Letter of Transmittal

Date: 6-02-2026
Petition Map: 26-42

Metronet would like to place a fiber optic cabinet in the Right-of-Way along Rosa Parks Blvd. in Detroit. This cabinet will be used to regenerate the light signal within the transport fiber.

METRONET NETWORK CABINET CONSTRUCTION DRAWINGS

1400 Rosa Parks Blvd

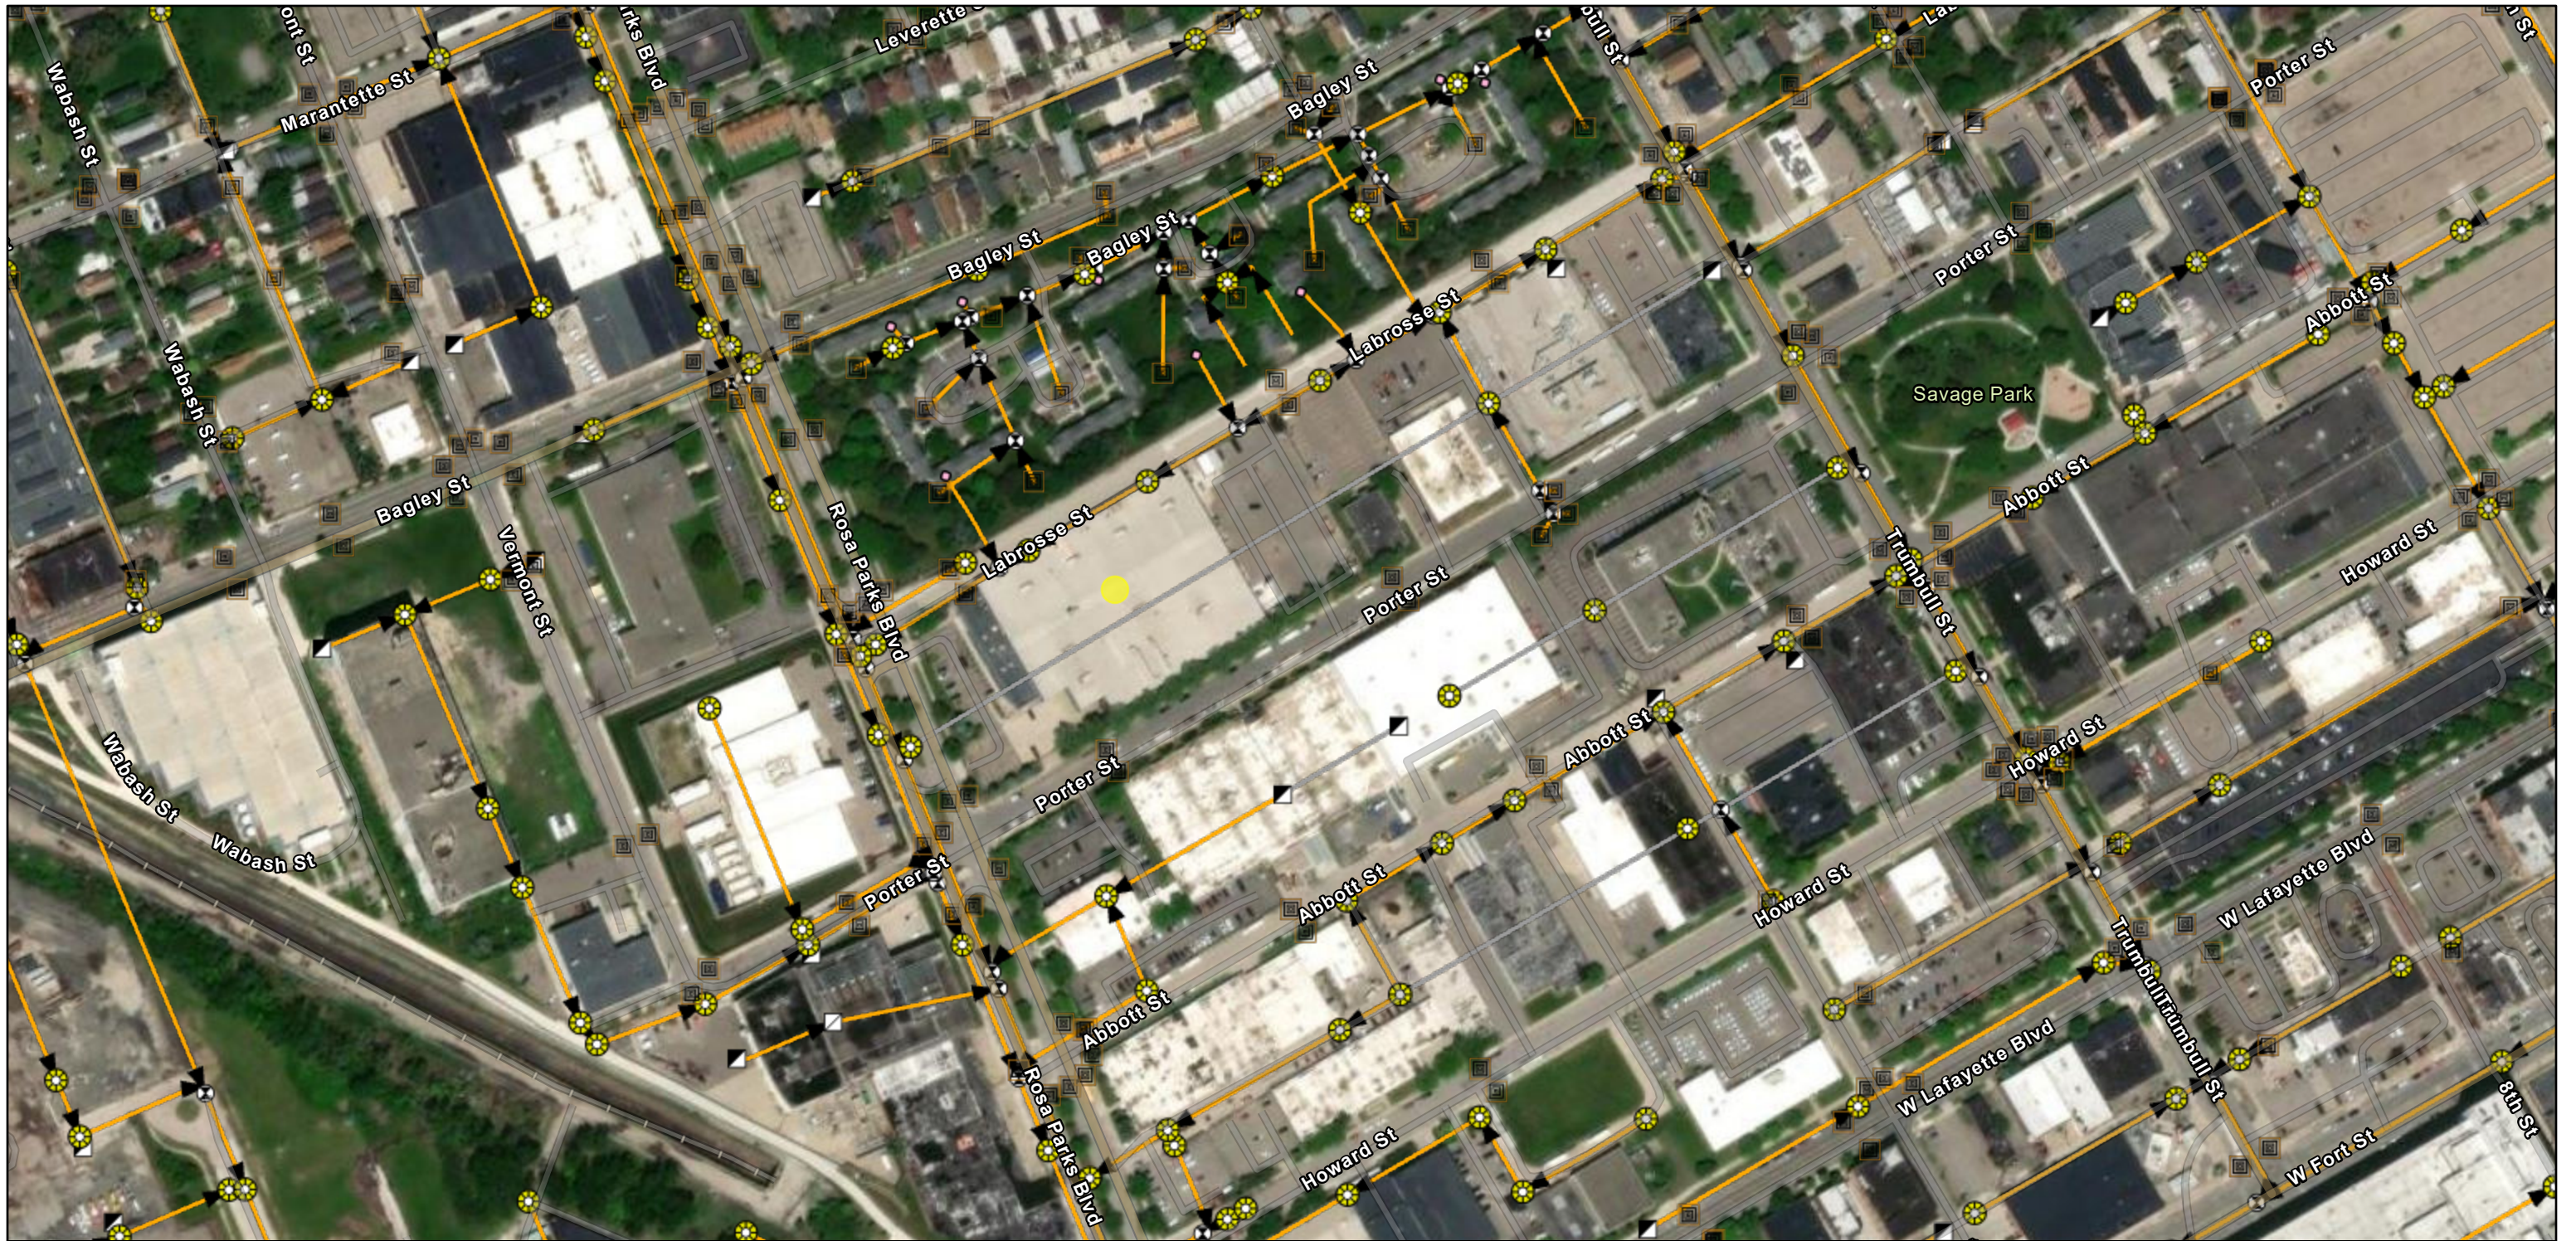
DWSD records indicate there is DWSD assets in the public right-of-way requested for encroachment. DWSD has no objections to the requested encroachment subject to the attached provision for encroachment is followed.
--

10. It is DWSD's requirement that no encroachment has a vertical clearance of less than 16 feet from the ground surface over DWSD water mains and/or sewers.
